| 8802-3/802.3 REVISION REQUEST |

REQUESTED REVISION:  
STANDARD: IEEE Std 802.3ab-1999  
CLAUSE NUMBER: 40C.2.1 and Figure 40C-2  
CLAUSE TITLE: Auto-Negotiation Transmit state machine add-on  
for 1000BASE-T

| REV REQ NUMBER: 1042

Figure 40C-2 as modified by Revision requests 1042 to 1049 - Changes annotated

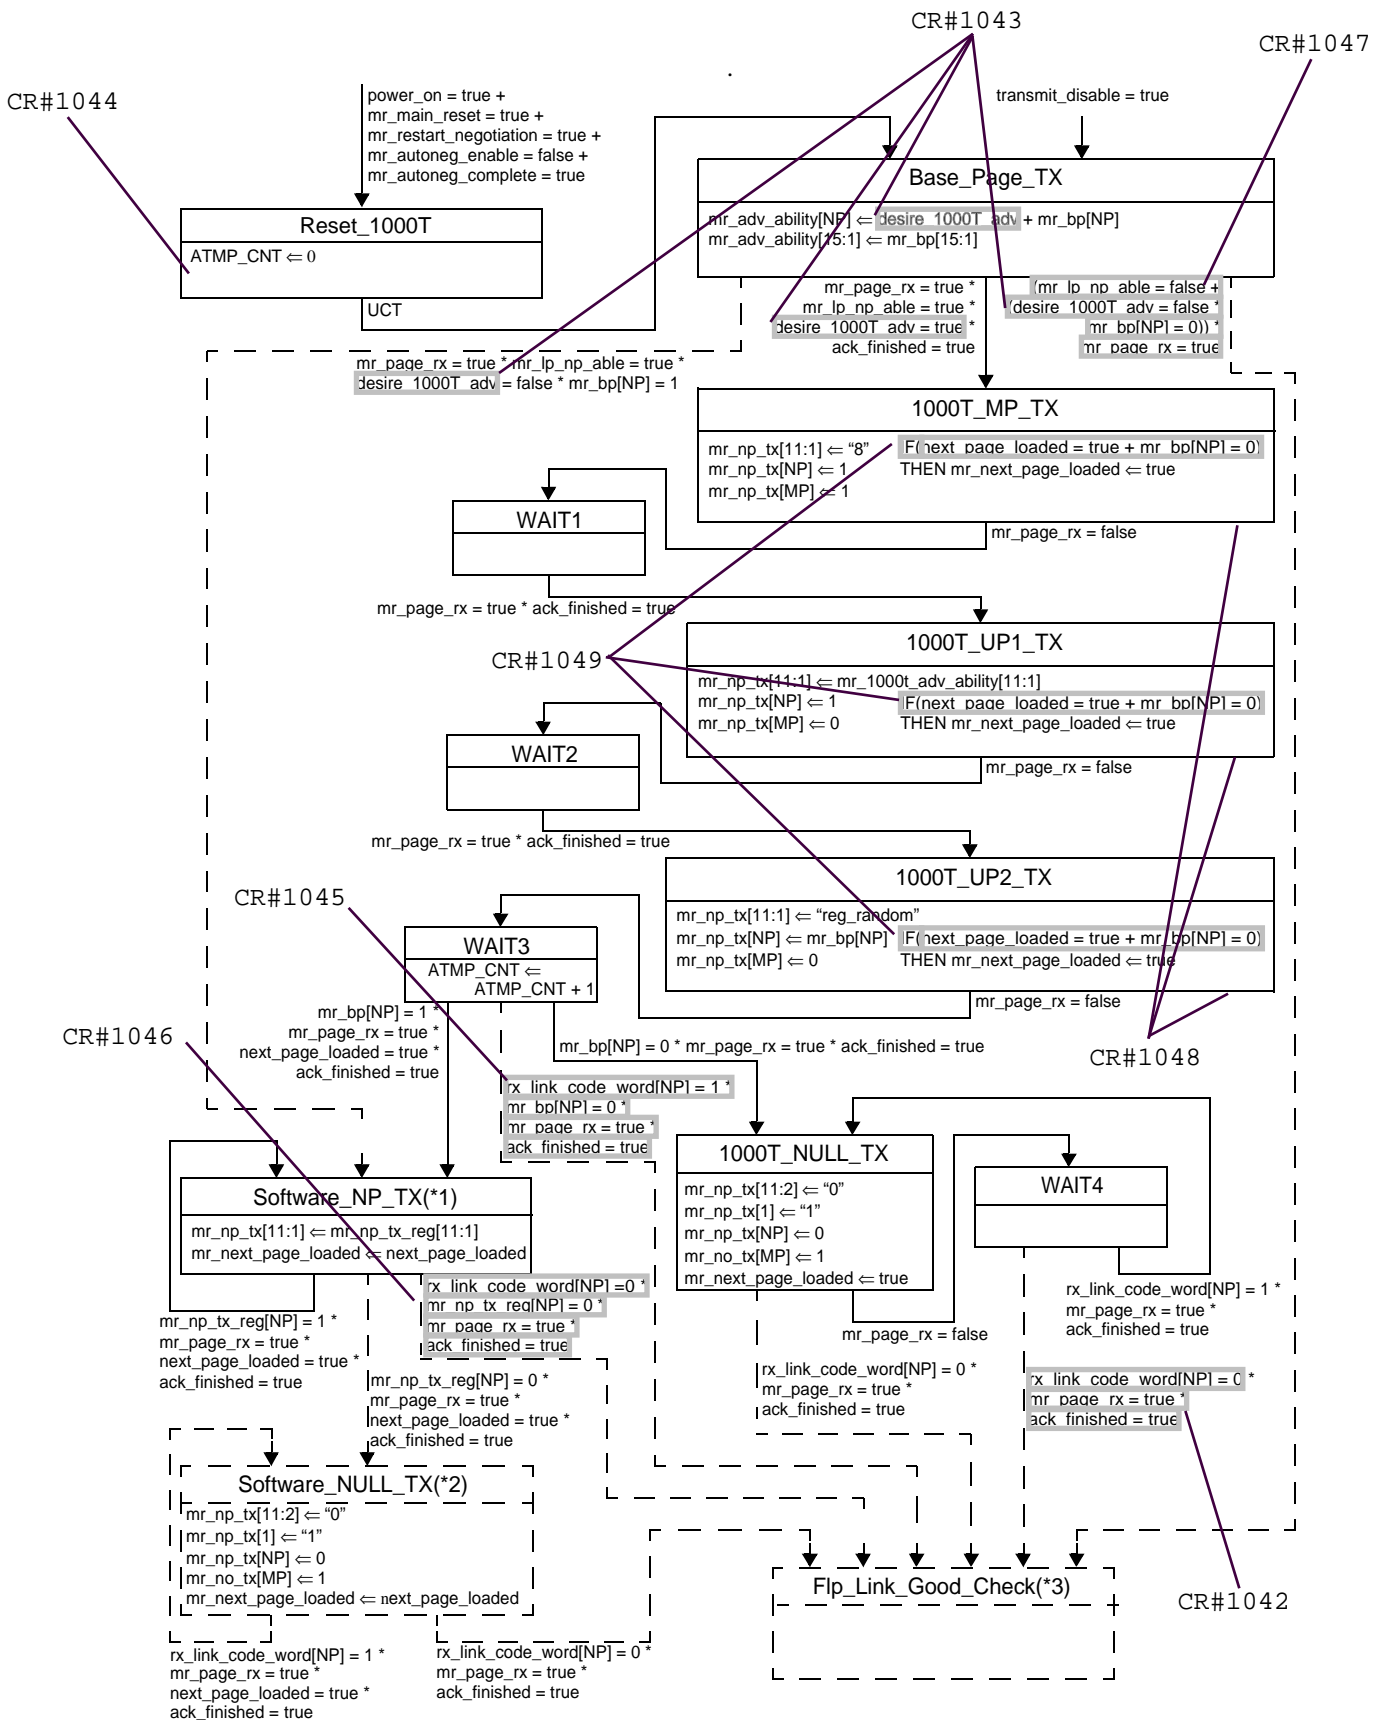
Add a transition in Firgure 40C-2 from WAIT4 to the  
Flp\_Link\_Good\_Check state. This transition will have the following  
requirement:

rx\_link\_code\_word[NP]=0 \* mr\_page\_rx=true \* ack\_finished=true

The Auto-Negotiation Transmit state machine add-on for 1000Base-T  
has the possibility of entering a deadlock in the WAIT4 state. If  
a link partner starts transmitting its last Next Page  
(rx\_link\_code\_word[NP]=0) and the device is in WAIT4, there are no  
exit conditions.
